J. F. DAVIDSON - CIVIL ENGINEER  
APPROVED: J. F. Davidson, 8/19/67  
CITY OF RIVERSIDE, CALIFORNIA  
DEPARTMENT OF PUBLIC WORKS  
R/S 706  
S-285A  
1 of 2

**CITY OF RIVERSIDE, CALIFORNIA**  
 DEPARTMENT OF PUBLIC WORKS  
 SEWER PLAN & PROFILE  
 GRAND AVENUE

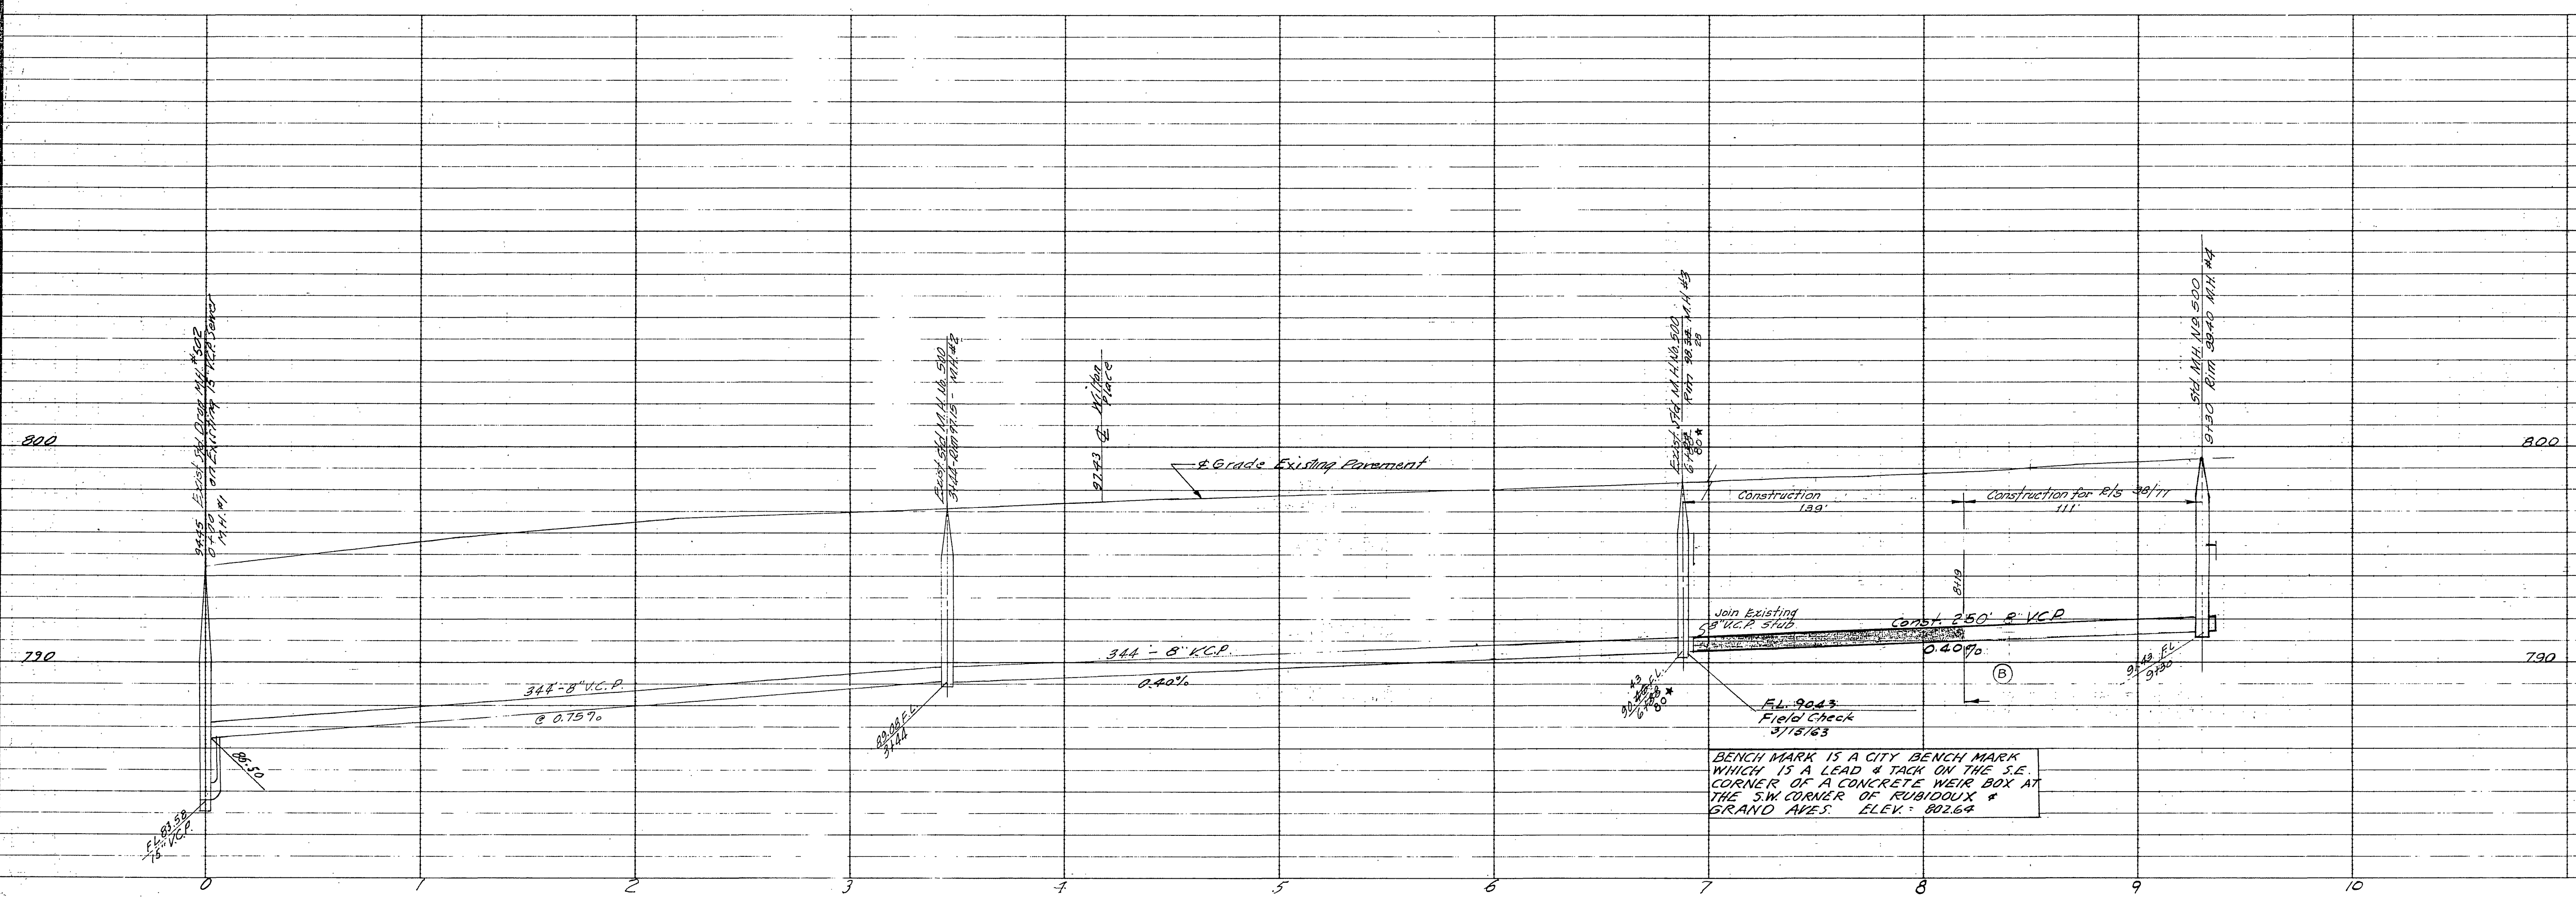
A. Revision of Grand Avenue Right-of-Way. The same proposed to occur late 1967, and found wrong the location of the drain in relation to the location of the sewer line.

HORIZ. SCALE 1"=40' VERT. SCALE 1"=4'  
 APPROVED BY: *J. F. Davidson* DIRECTOR OF PUBLIC WORKS  
 DATE 4-2-61  
 NO. **S-285A**  
 SHEET 1-9/13

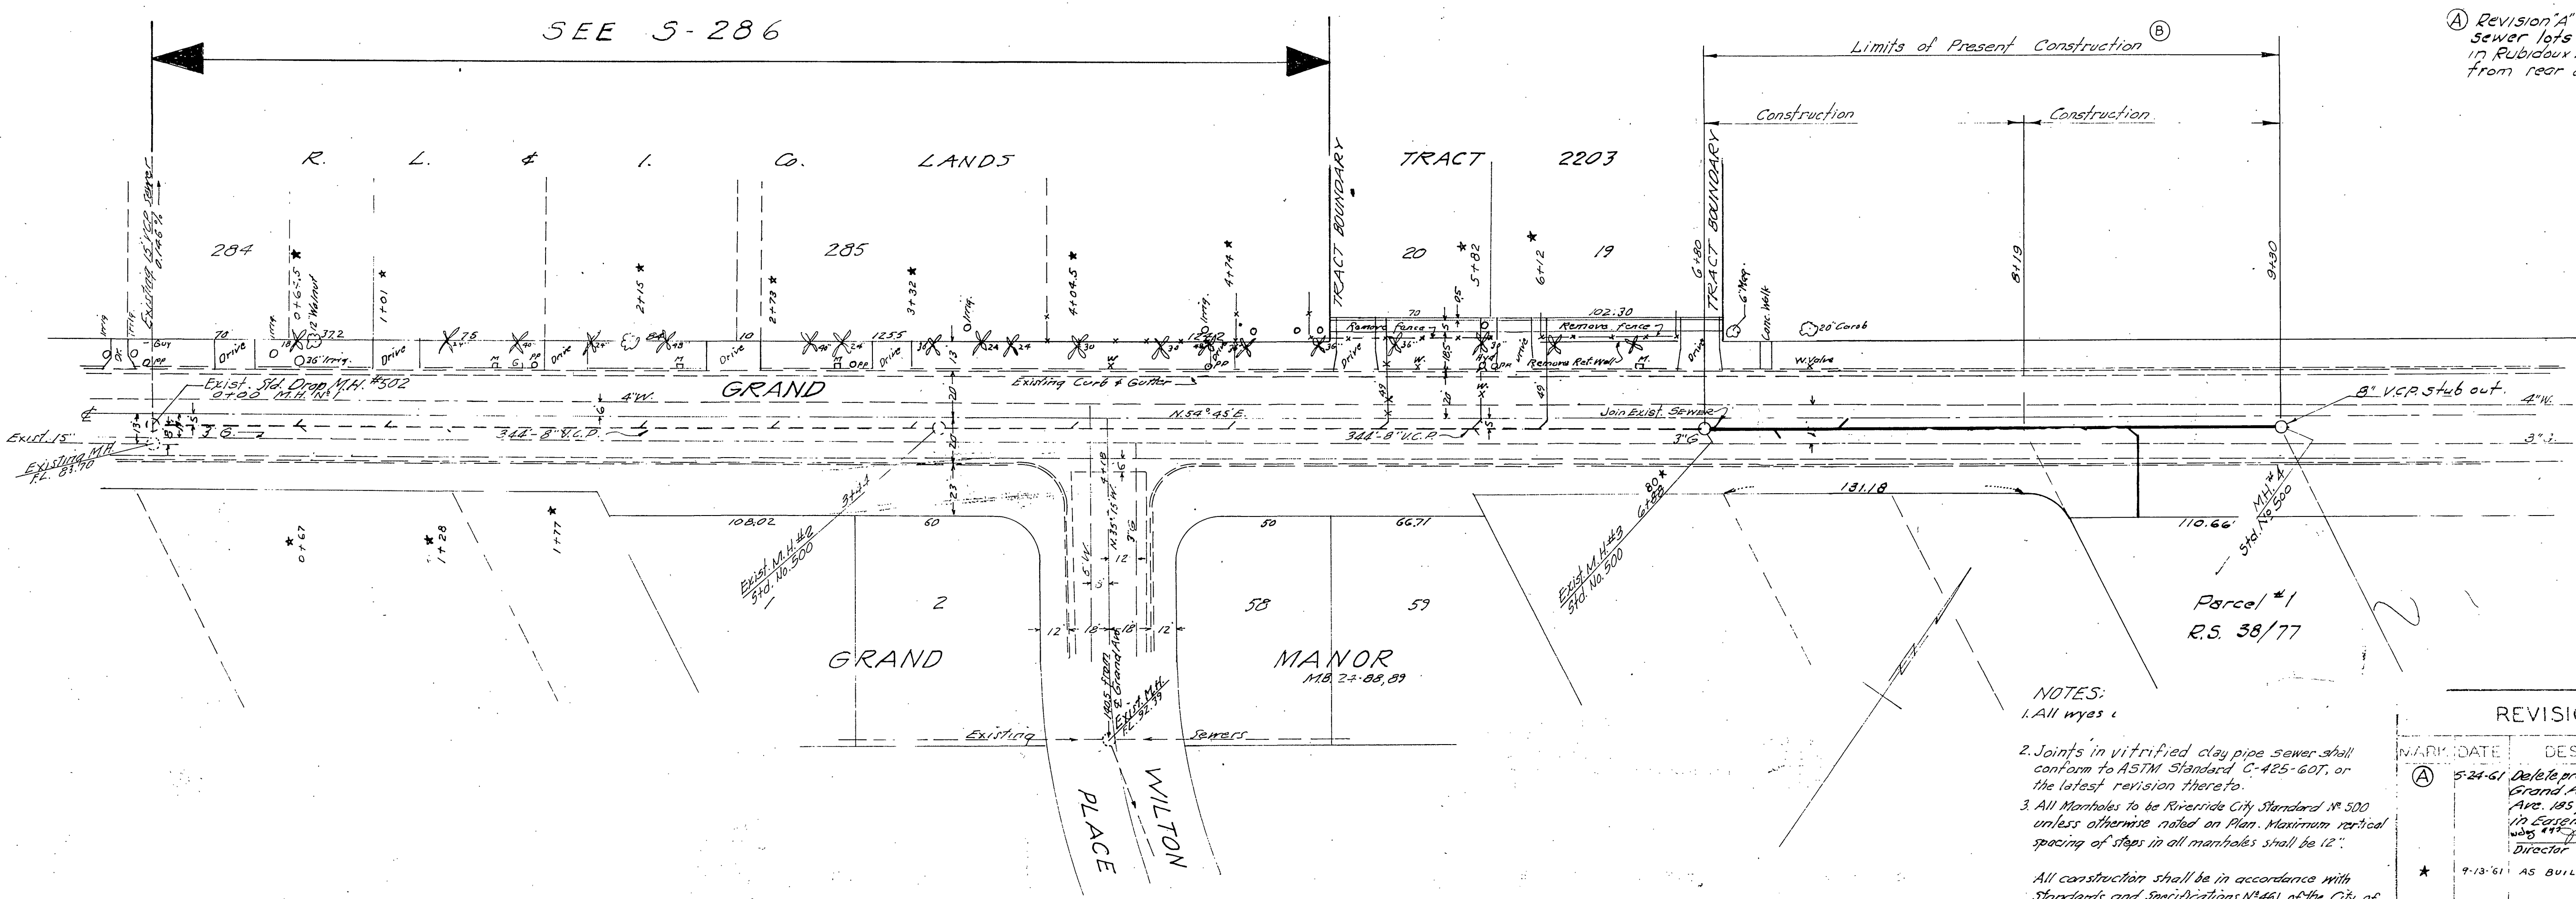
Revision 'A' at Grand Ave and Rubidoux Ave was proposal to sewer lots 10 & 11, but found impossible because of storm drain in Rubidoux Ave. With Revision 'A' lots 10 & 11 were sewerred from rear of lots

REVISIONS	
MARK	DESCRIPTION
(A)	5-24-61 Delete proposed sewer in Grand Ave. S. from Rubidoux Ave. 185 ft. and Condit. Sewer in Easement on Lots 10 & 11 was 115' from 10+00 to 11+00
*	9-13-61 AS BUILT N.E.C.
